PHOTOGRAPHS

PHOTOGRAPH #12

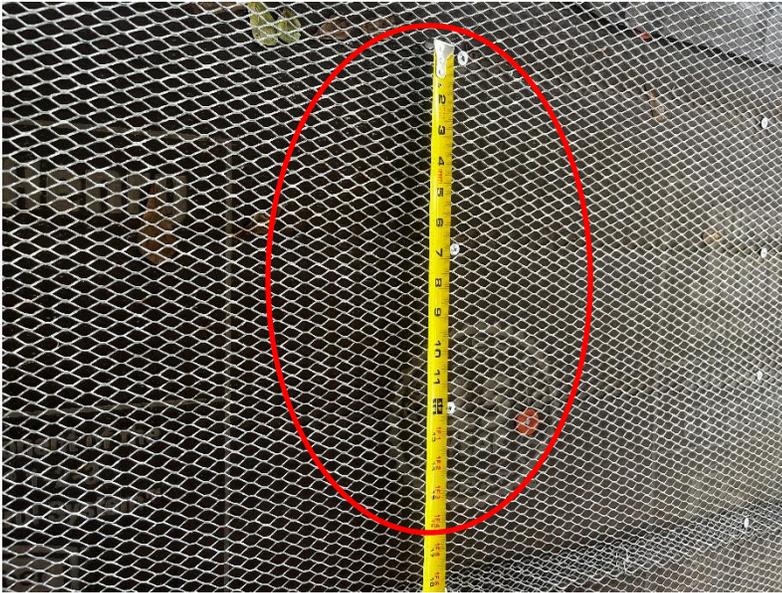
Stucco subcontractor applying self-furring galvanized metal lath as per specification and drawings.

PHOTOGRAPH #13

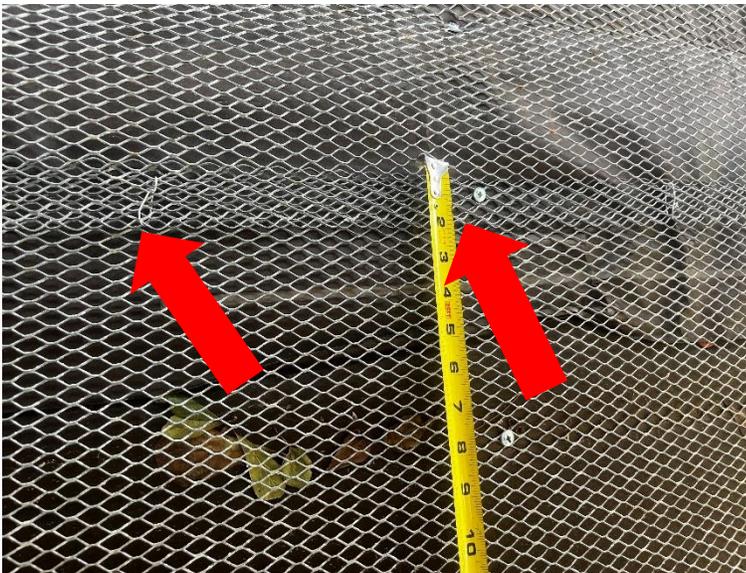
Metal lathing attached to framing at 6" with waffle head zinc coated self-tapping screw.

PHOTOGRAPH #24

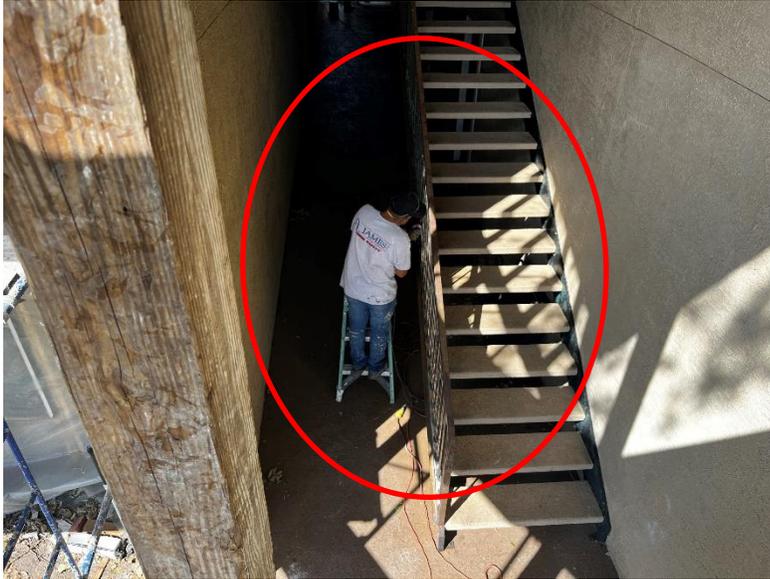
Copper Green wood preservative applied at base plate and lower 2' of framing as per specifications.
